Forward Silicon Tracker - internal STAR review

Review Date: August 3rd 2020

Report Date: August 10th 2020

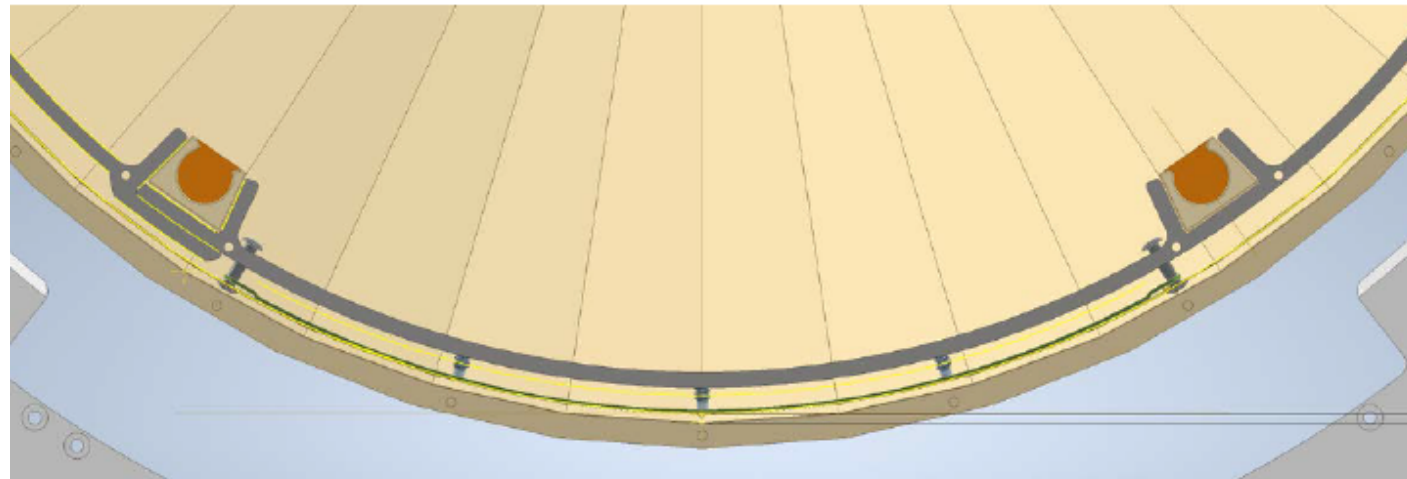
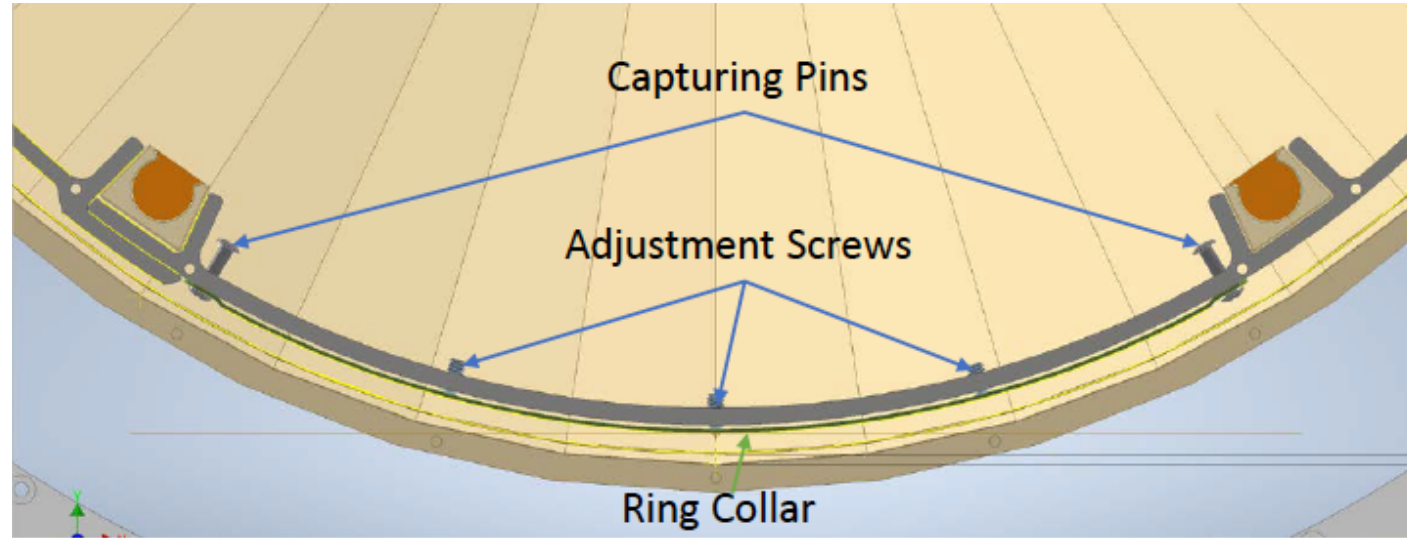
- Set screws are used to adjust the detector installation tool. Longer screws should be used and nuts installed after survey to lock it into position. The figure showing the adjustment screws is shown on the next slide.
